Re: Des Moines Independent Community School District
Moulton Elementary School – Kitchen Cooler Improvements
1541 Eighth Street
Des Moines, Iowa 50314

ADDENDUM #1

February 15, 2021

SECTION DETAIL - MECHANICAL SCREEN

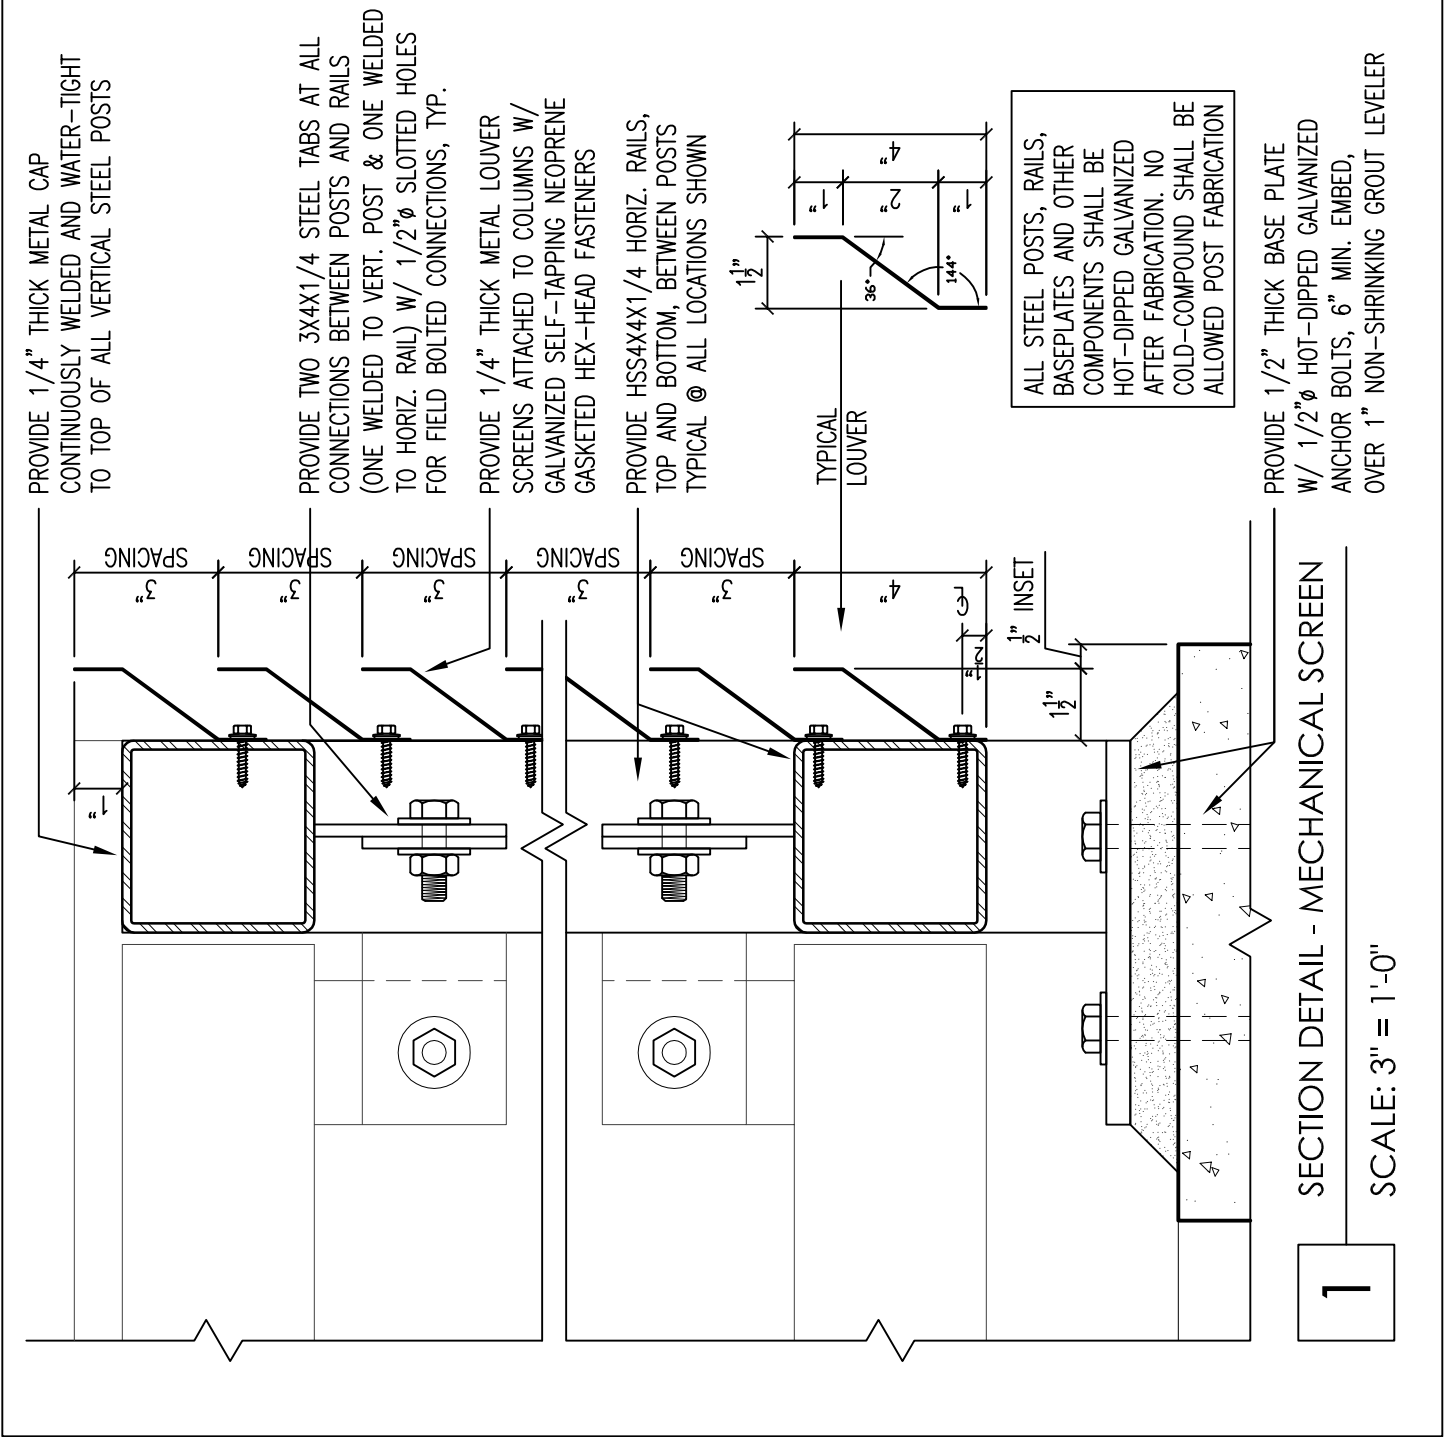
Item #5: **ADDITION – ASD 1**

Add drawing ASD 1 to the drawing set.

Mechanical screening louvers shall be fabricated steel in lieu of pre-finished VERT-A-CADE CSI blades.
